RENESAS TECHNICAL UPDATE

Product Category	MPU/MCU	Document No.	TN-V85-A026A/E	Rev.	1.00
Title	Precaution of A/D conversion accuracy		Information Category	Technical Notification	
Applicable Product	V850E2/Mx4 series	Lot No.	Reference Document	User Manual of each product	
		All lots

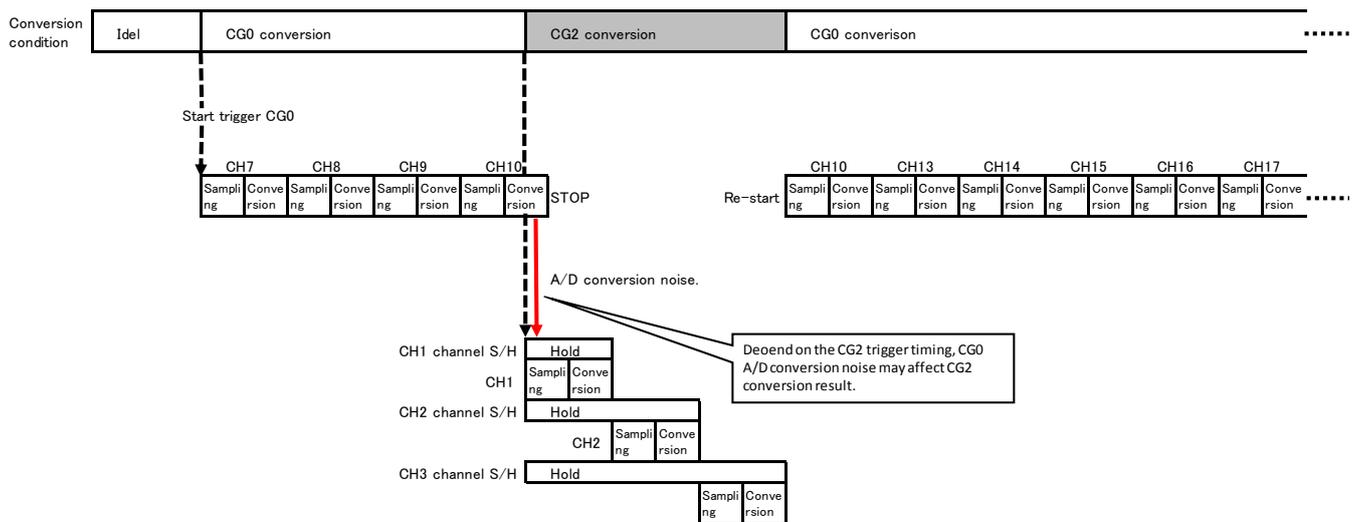
1. Restriction

There is a possibility that A/D conversion accuracy of high priority CG become worse when following both condition is used.

- 1) During the A/D conversion of low priority CG (e.g. CG0), conversion trigger of the high priority CG (e.g. CG2) occur.
- 2) The channel S/H function of high priority CG (e.g. CG2) is enabled.

Note: The above case is one of an example of CG combination. The CG priority is CG2 > CG1 > CG0.

CG0(Low priority) = CH7, CH8, CH9, CH10, CH13, CH14, CH15, CH16 (Continuous conversion mode.)
 CG2(High priority) = CH1, CH2, CH3 (Channel S/H function is enabled.)

2. Countermeasure

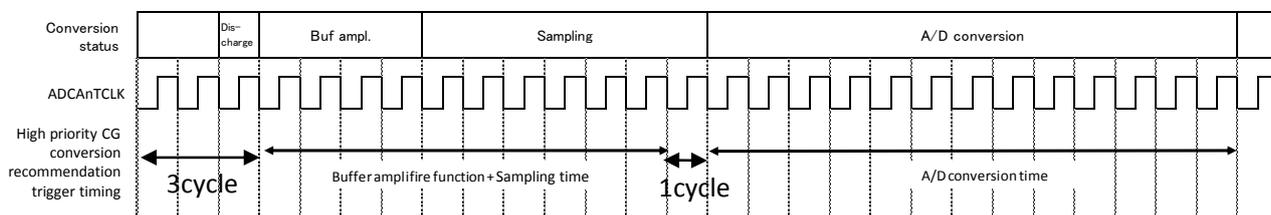
- 1) Low priority CG (e.g. CG0) A/D conversion have to be finished 3 ADCAnTCLK before the conversion trigger of high priority CG (e.g. CG2), if the CG2 contains the channels which channel S/H is available.
- 2) If there is a case that high priority CG (e.g. CG2) conversion trigger occur during the conversion of low priority CG (e.g.CG0), disable the high priority CG channel S/H function.
- 3) If the both condition mentioned in previous page need to be used, adjust high priority CG (e.g.CG2) conversion trigger timing not to occur 3 cycle period before “buffer amplifier function + sampling time” and 1cycle period before “A/D conversion time”

Example condition: Discharge function: ON, Buffer amplifier function: ON, ADCAnCTL1.ADCAnCTYP=0

Note: Even if trigger timing is adjusted above recommendation time, conversion error specified in Data Sheet can't be removed.
